Transportation Response to s92 – Taumatatotora Wind Farm – RM200019

The following provides responses to the request for information on the above consent application, dated 7 September 2020.

Sight Access Visibility

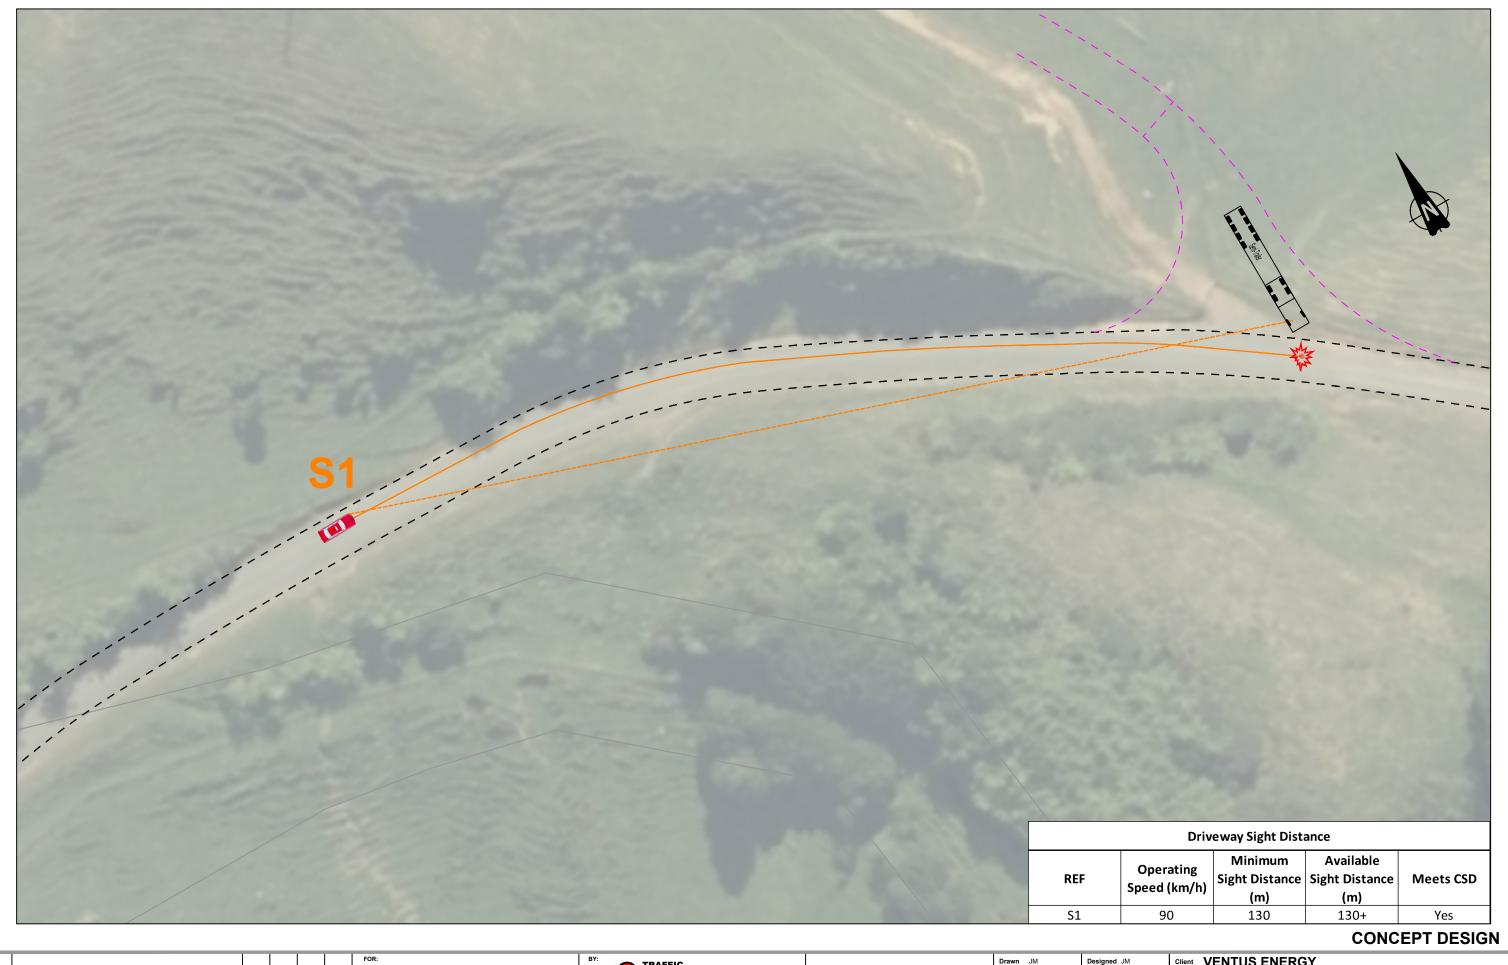
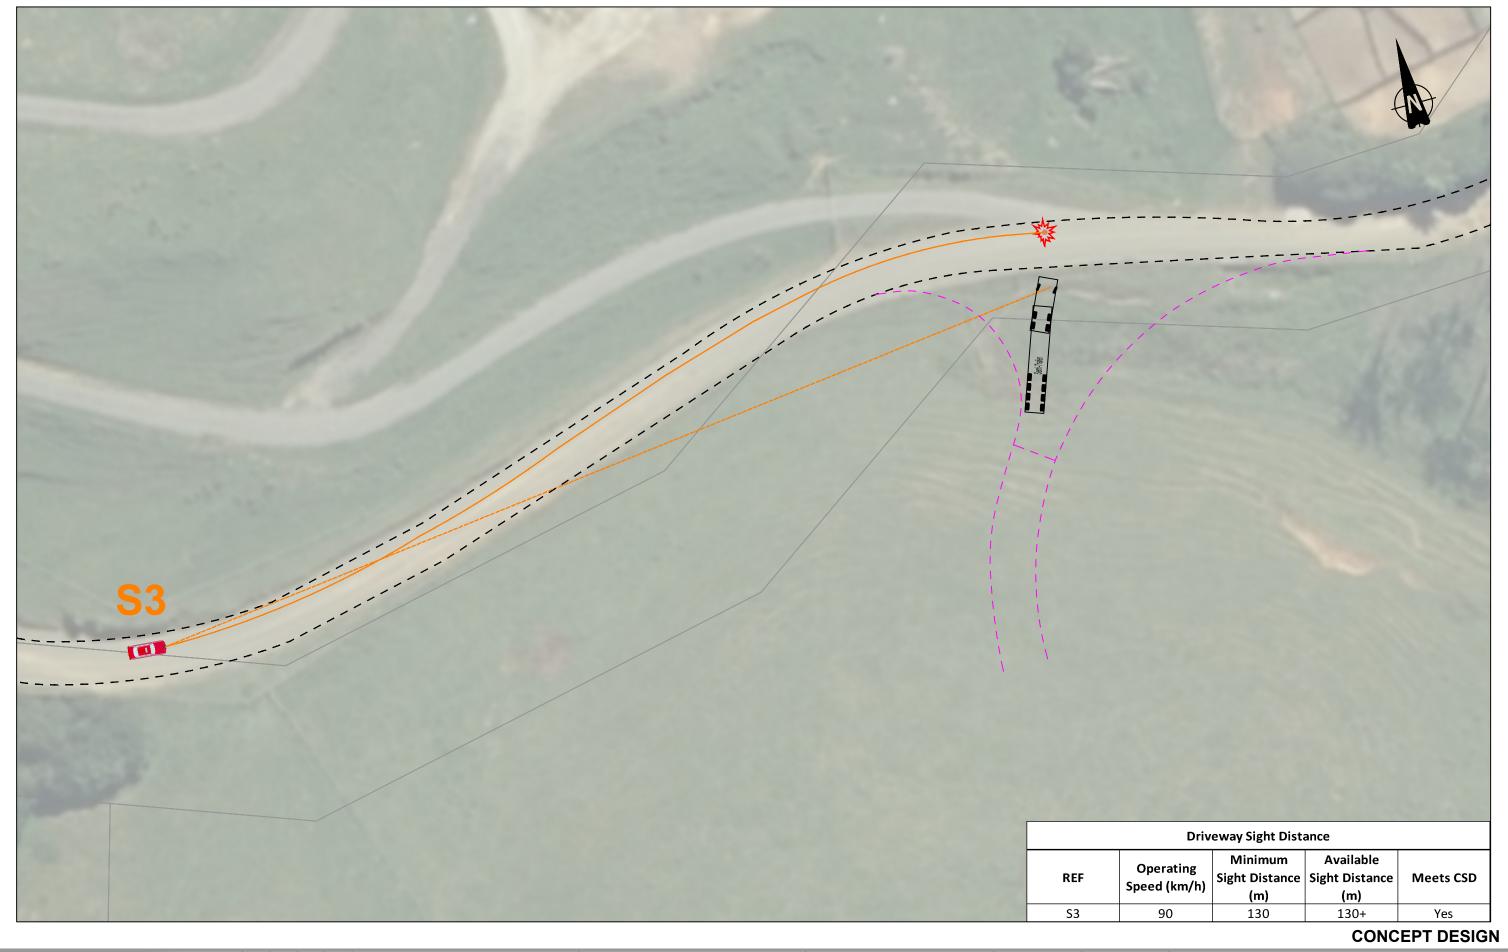
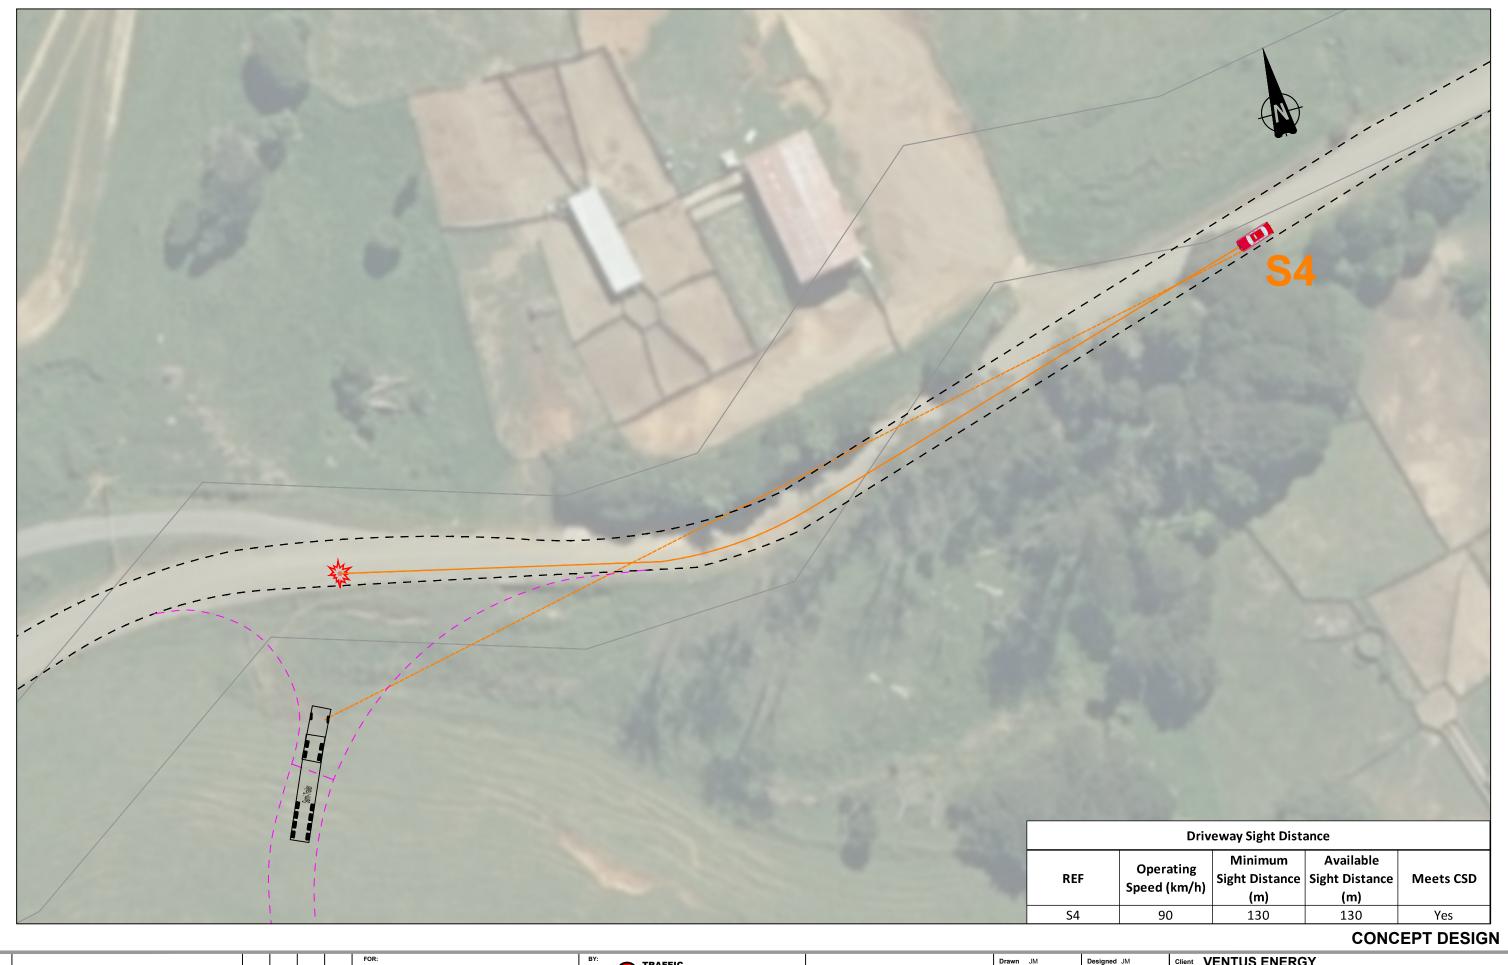
Please provide an assessment of the achievable sight lines at the site access should be undertaken to confirm whether sufficient sight distance exists to meet the minimum requirements of NZTA Guidelines RTS 6.

An assessment has been undertaken to check sight lines at the site access, and these meet design standards as shown in **Appendix 3** of the report. The sight lines are based on the existing speed limit in the area, which is 100km/h. It should be noted that sight lines are likely to improve during the construction period with a TMP in place near the site access. A TMP would likely reduce the speed limit and therefore reduce vehicle speeds near the sight access, thereby improving safety for access to the site.
